UNITED STATES PATENT AND TRADEMARK OFFICE

APPLICATION NO.	FILING DATE	FIRST NAMED INVENTOR	ATTORNEY DOCKET NO.	CONFIRMATION NO.
10/665,469	09/22/2003	Toshikazu Onishi	60188-660	5515
7590	01/13/2006		EXAMINER	
Jack Q. Lever, Jr. McDERMOTT, WILL & EMERY 600 Thirteenth Street, N.W. Washington, DC 20005-3096			NGUYEN, PHILLIP	
			ART UNIT	PAPER NUMBER
			2828

Office Action Summary	Application No.	Applicant(s)	
	10/665,469	ONISHI, TOSHIKAZU	
	Examiner	Art Unit	
	Phillip Nguyen	2828

DETAILED ACTION

FIG. 2

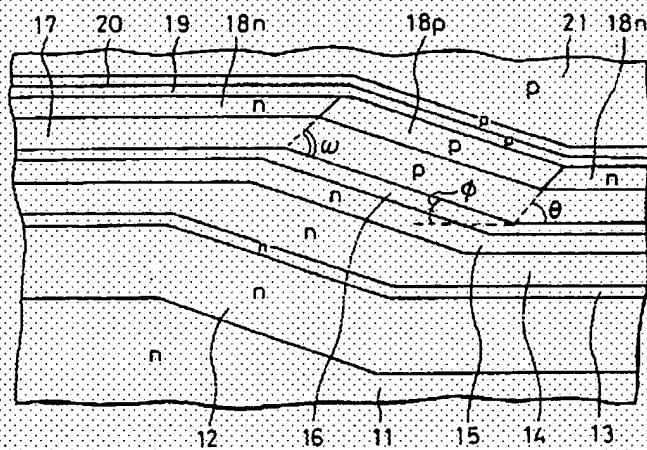
With respect to claims 1 and 4, Anayama discloses in Fig. 2 (above) a semiconductor laser device comprising an active layer; a first cladding layer 17 formed on the active layer, the first cladding layer being doped with first impurity (Mg) and a second cladding layer 18 formed on the first cladding layer, the second cladding layer being doped with a second impurity (Zn) different from the first impurity wherein the first cladding layer has the same conductivity type (p type) as that of the second cladding layers and the first cladding layer has a resistivity higher than that of the second cladding layer. Anayama also teaches each of first and second cladding layers being made of a compound semiconductor containing phosphorous (col. 8, lines 60-65).

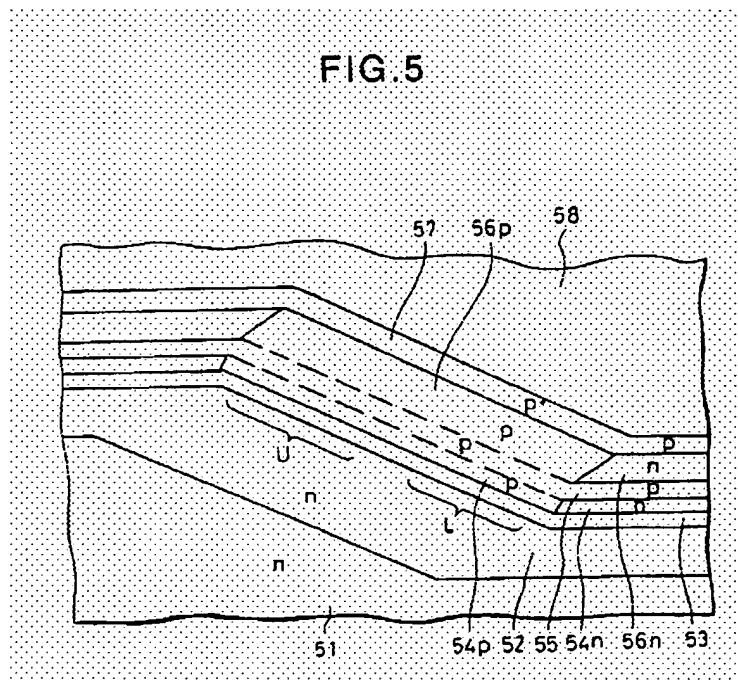
With respect to claim 6, Anayama discloses in Fig. 4 and 5 (above) a laser as claimed in claim 1 with the first cladding 54 and the second cladding 55/56. Besides teaching a first impurity and a second impurity and Anayama also teaches a third impurity (selenium) which creates the n type conductivity on the sides of cladding layer 54 and denoted as 54n.
